**REVISED PLANNING PROPOSAL FOR THE VICTORIA ROAD PRECINCT,**  
**MARRICKVILLE (PP 2015 MARRI 004 00)**  
**OTHER MATTERS FOR CONSIDERATION**

This Tab provides consideration and an assessment of other matters in respect of the Planning Team Report for the Revised Planning Proposal for the Victoria Road Precinct, Marrickville.

### Constraints Map

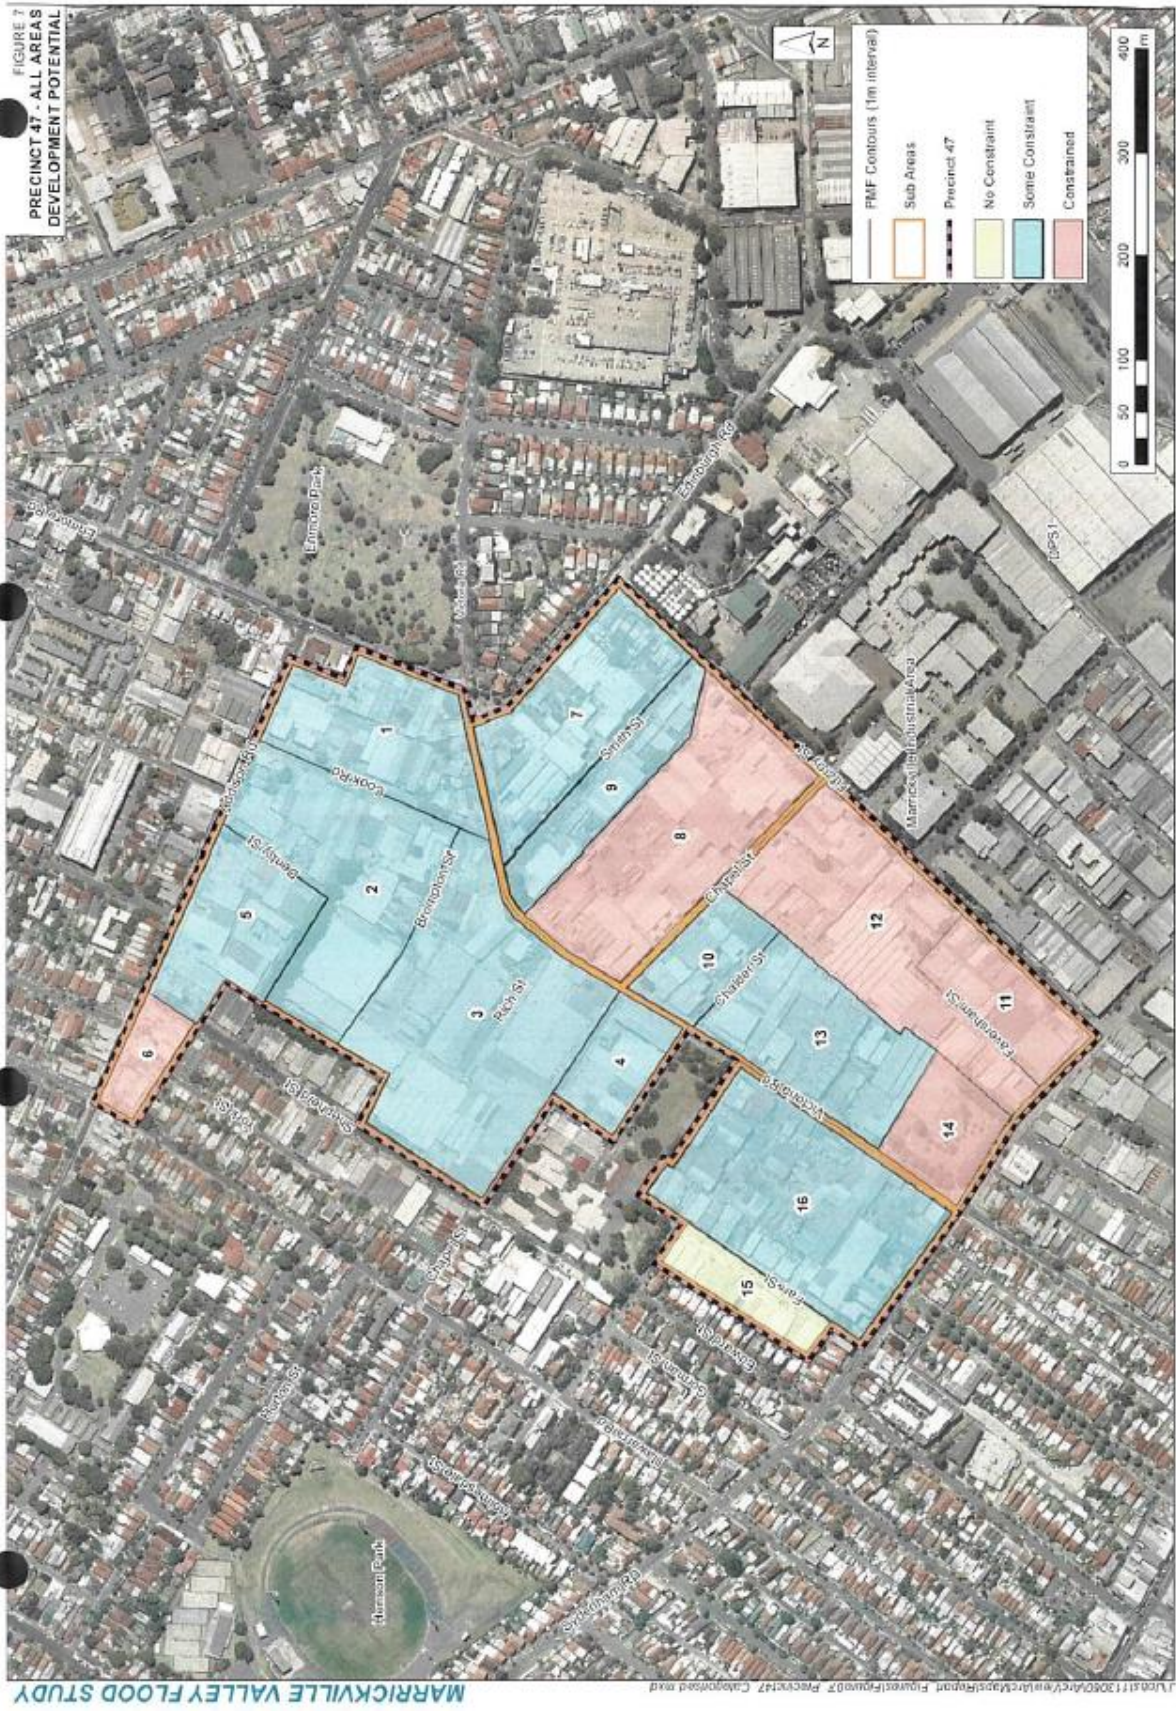
The report divides the Precincts into a number of sub-areas and provides an assessment of the constraints and opportunities (see Figures 2 to 6 in the Flood Liability Report and attached maps at the end of this document). An assessment of the sub-areas is listed below. The planning proposal states the industrial areas around Fitzroy and Chapel Streets (particularly to the south of Victoria Road are the most constrained), while land to the north is somewhat constrained. It is noted that R4 High Density Residential zoning has been requested in the area around Wicks Park and this area has been designated as 'constrained'.

Areas 3 and 4 are on the north side of Victoria Road and proposed for B5 Business Development zoning. Victoria Road, Cook Road and Brompton Street are not suitable for egress. There is an open channel at the northern edge of Area 4 but has less flood constraints as it is higher.

*Sub areas 1-6*

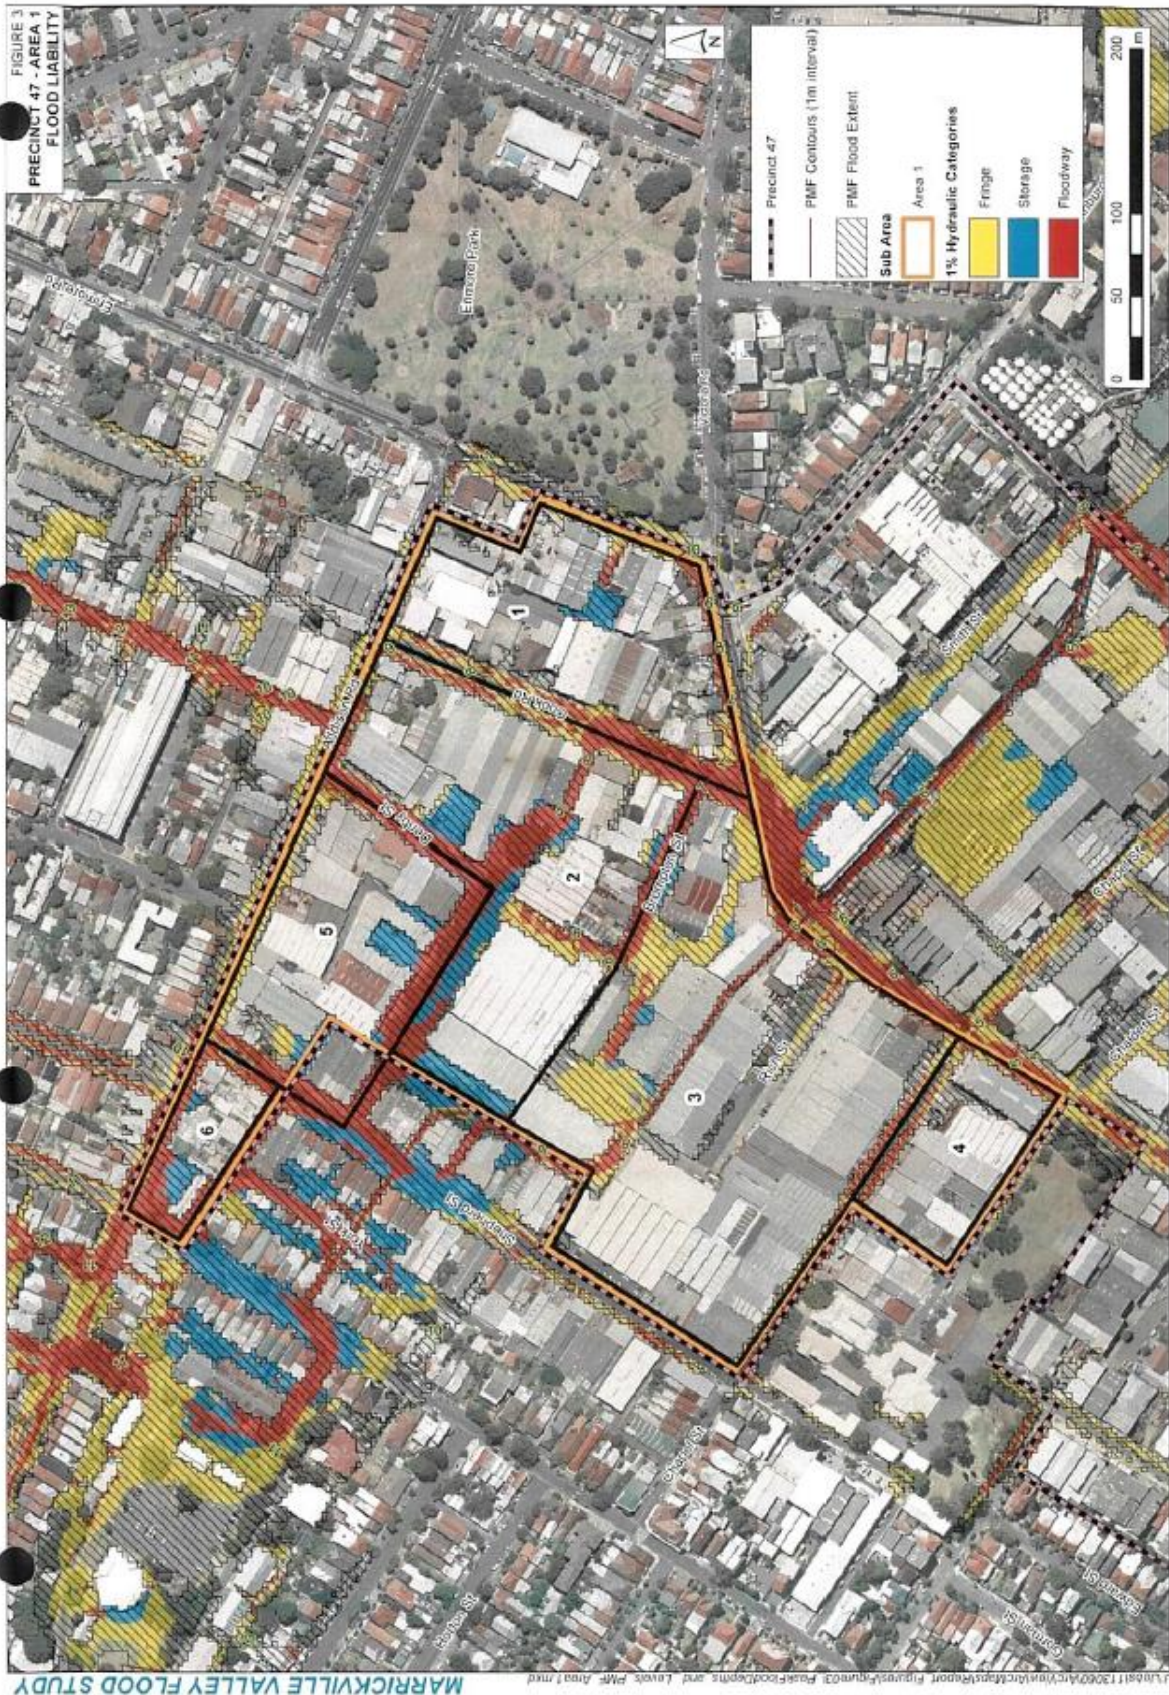
Areas 9 and 10 are proposed for B5 Business Development zoning. Both Areas have substantial egress issues (via Victoria Road). Area 9 is flood affected, while Area 10 is relatively flood free.

It is proposed to rezone the northern portion of Area 8 to B5 Business Development. While this zone does not permit residential development, it is envisaged that the area will become commercial office space and showroom area. The report notes the area is bound by an open channel, three flooded roads (Fitzroy Street is heavily flooded). It states that egress is very poor, the area is heavily flood affected, and less land is available for development (without causing unacceptable impacts).

*Sub areas 7-9*

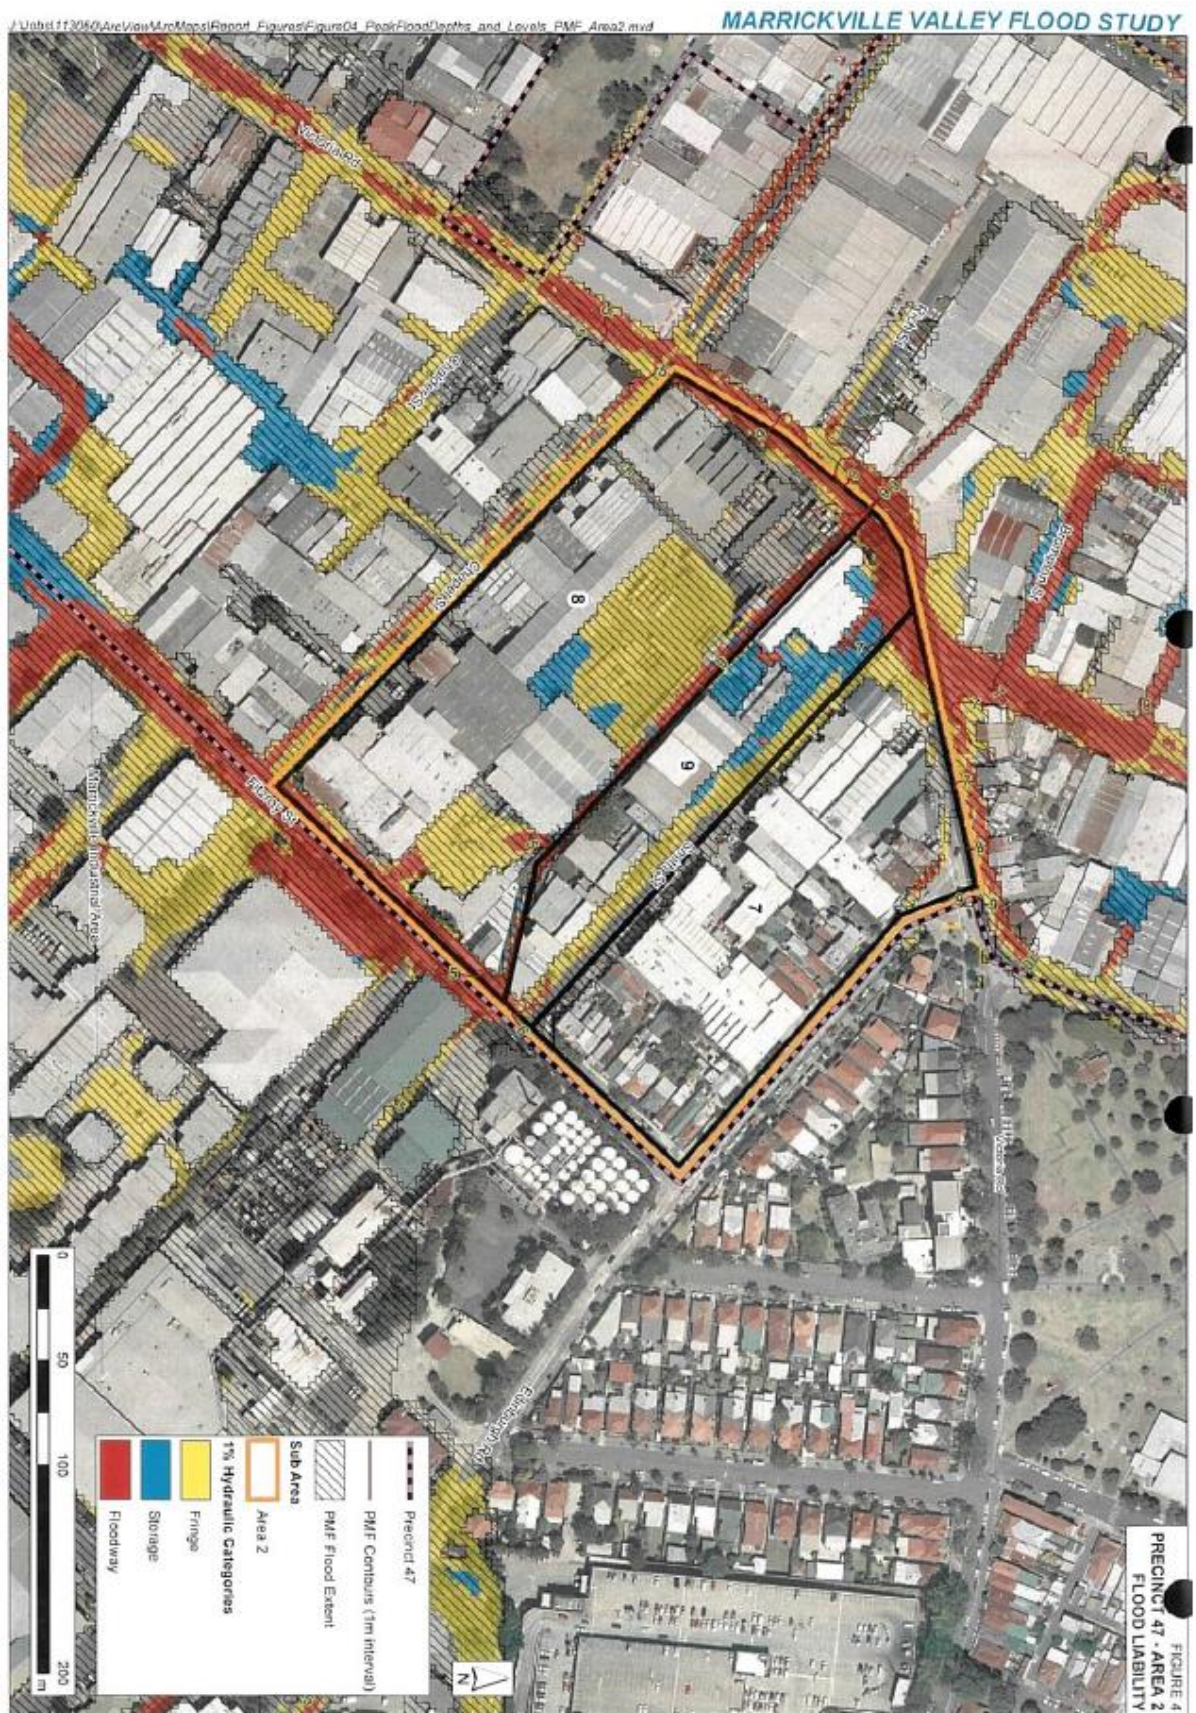
Three sub-areas which have been identified for rezoning (in full or in part) have been designated as constrained – Wicks Park (Area 14), the industrial area at the southern edge (Faversham Street to Fitzroy Street – Area 12) and the industrial area (Victoria Road to Fitzroy Street) towards the south-east corner of the Precinct (Area 8).

Despite no development being proposed on Wicks Park, the park is severely flood affected and egress is poor. High density development is proposed around the park, potentially compounding affectation and egress issues, particularly in emergency situations.

Area 12 “suffers from a near total lack of egress” and is severely flood affected. The proposal seeks to rezone part of this land R4 High Density Residential and B5 Business Development (from Sydenham Road to Hans Place along Faversham Street). Rezoning part of this land for residential uses is not ideal. The report states that “uses will be constrained by a lack of ability to evacuate in the event of a flood”. This portion of the area is immediately adjacent to the Faversham Street area, which has severe flood affectation and a total lack of egress.

Given the significant amount of flood affected land in the Precinct, it is recommended that further consideration be given to flood controls, particularly the section 117 related to development in flood prone land. It is recommended that design solutions to mitigate flood impacts be placed on public exhibition. It is recommended the R4 High Density Residential zoning around Wicks Park be reconsidered given the high levels of flood affection and constraints on egress.

*Sub areas 10-14*

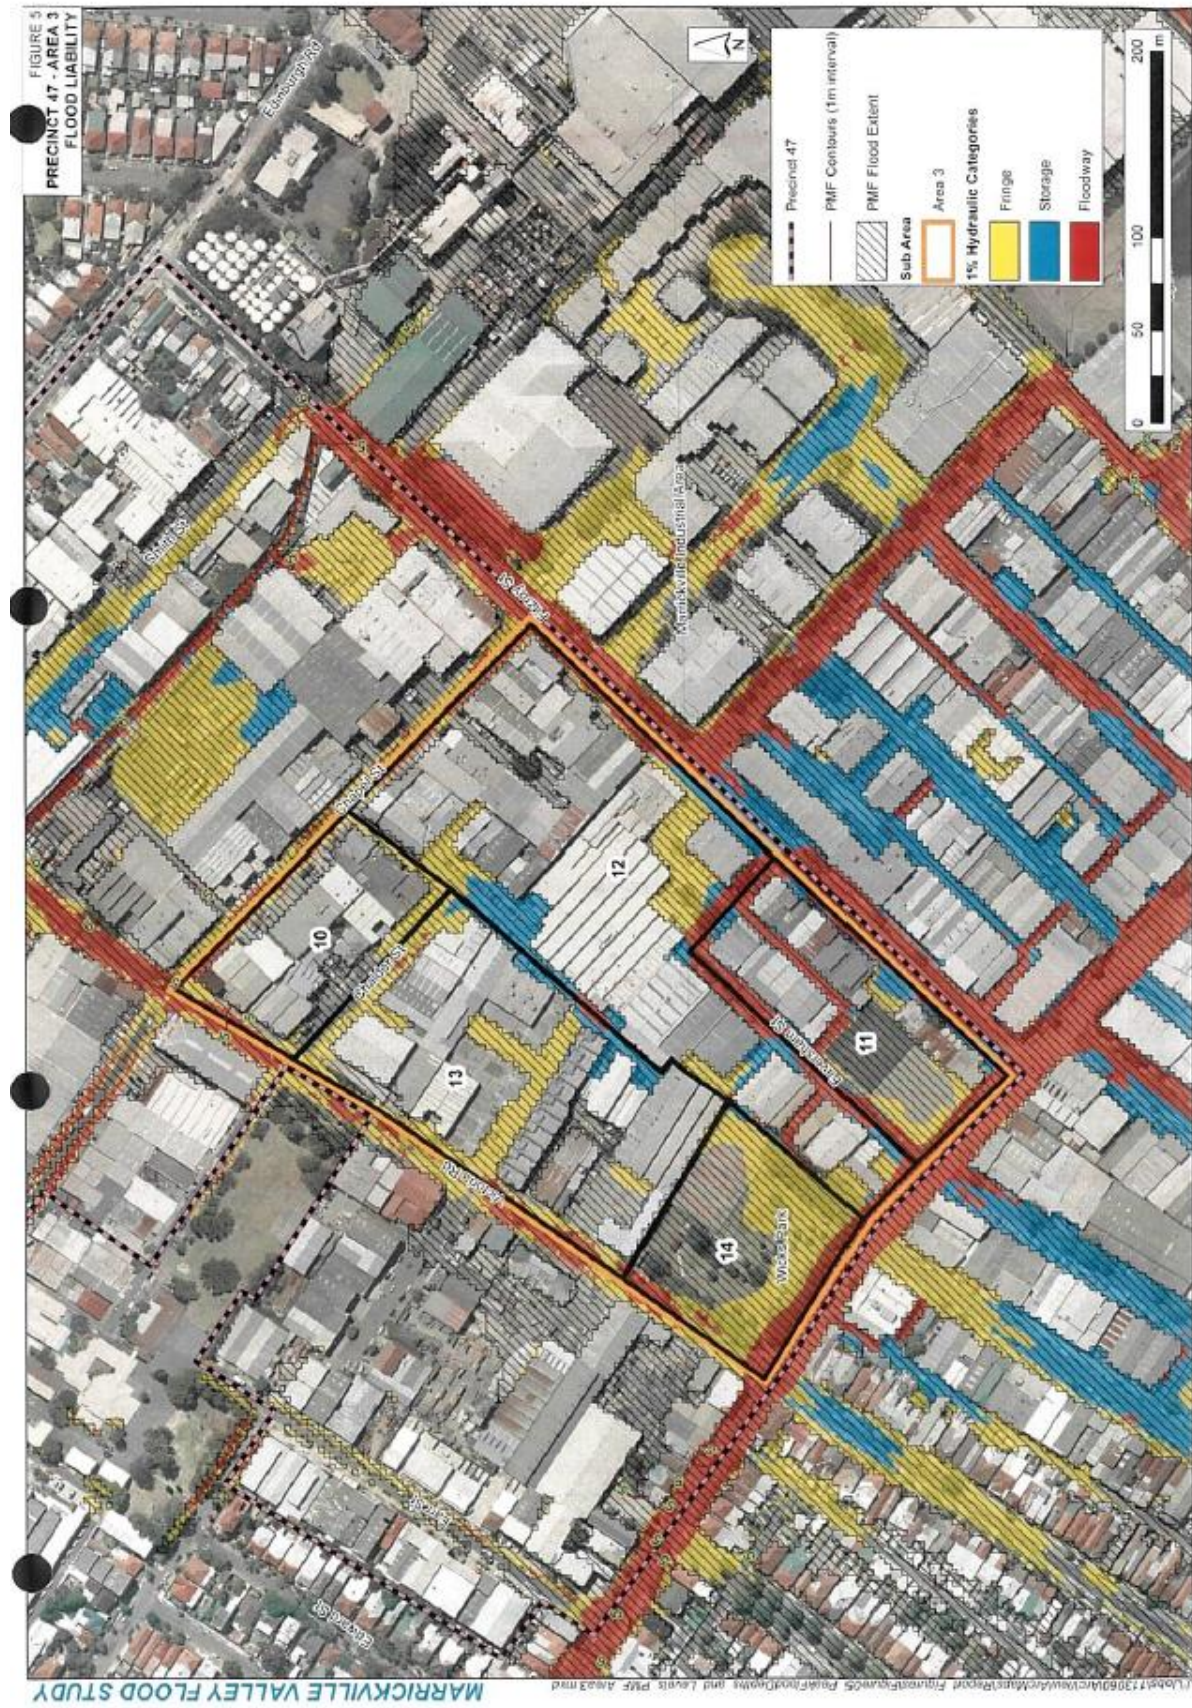
Area 13 is highly flood affected but has good egress. Area 15 and 16 are proposed for the intense residential uses. Area 15 has no flooding constraints, good egress and nearly flood free. Area 16 has one good source of egress (Farr Street), no egress to the north and the other two streets, Sydenham Road and Victoria Road are floodways. The report states development potential may be impacted for land fronting Victoria Road and Sydenham Road.

It should be noted Areas 15 and 16, where the denser development is suggested, has relatively good evacuation access. The report states Area 15 is “nearly entirely flood free”. Area 16 is affected in pockets around Victoria Road and egress along Farr Street would work.

## Marrickville Council Flood Planning Map (recently amended)

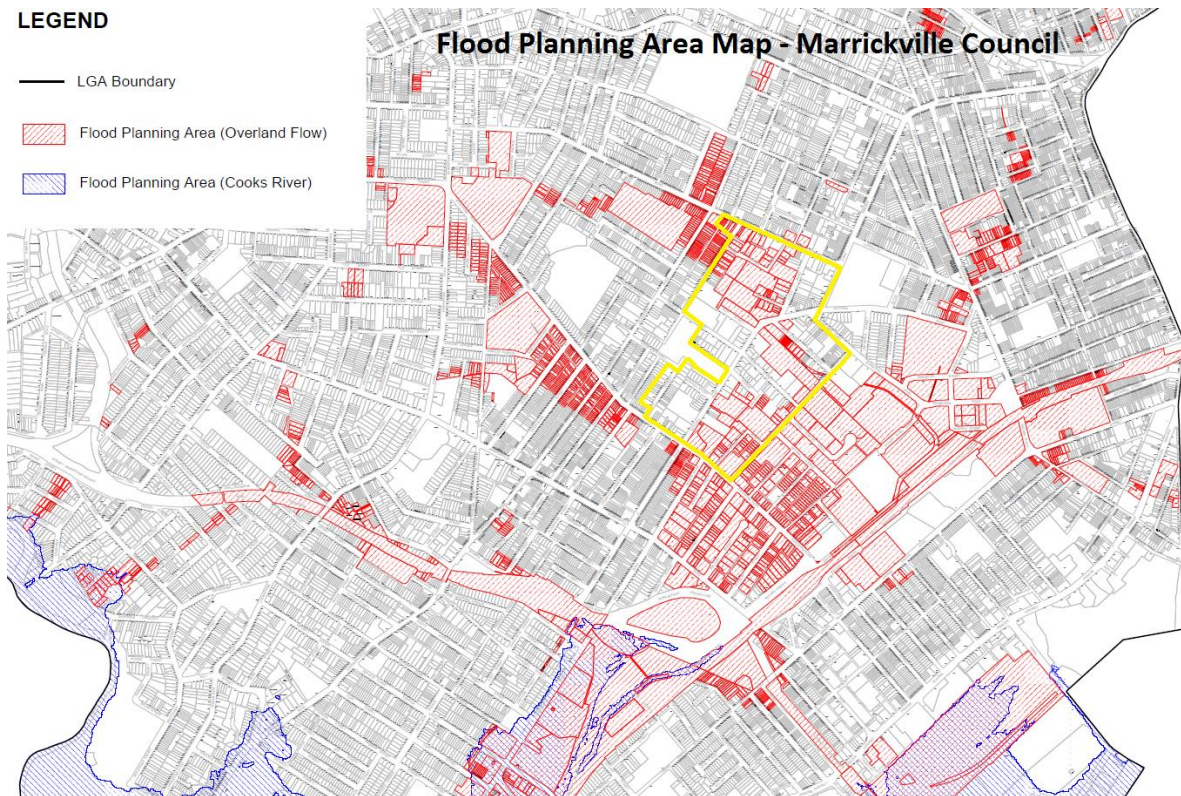
Marrickville Council recently reviewed their flood controls and flood maps. The amended flood maps are contained in the Marrickville DCP 2011 and have statutory weight by virtue of Clause 6.3 of the Marrickville LEP 2011. Under the amended flood maps, a large portion (approximately 50 per cent) of the Precinct is identified as Flood Liable Land and Flood Planning Area. The report condensed Council’s DCP flood controls to the following:
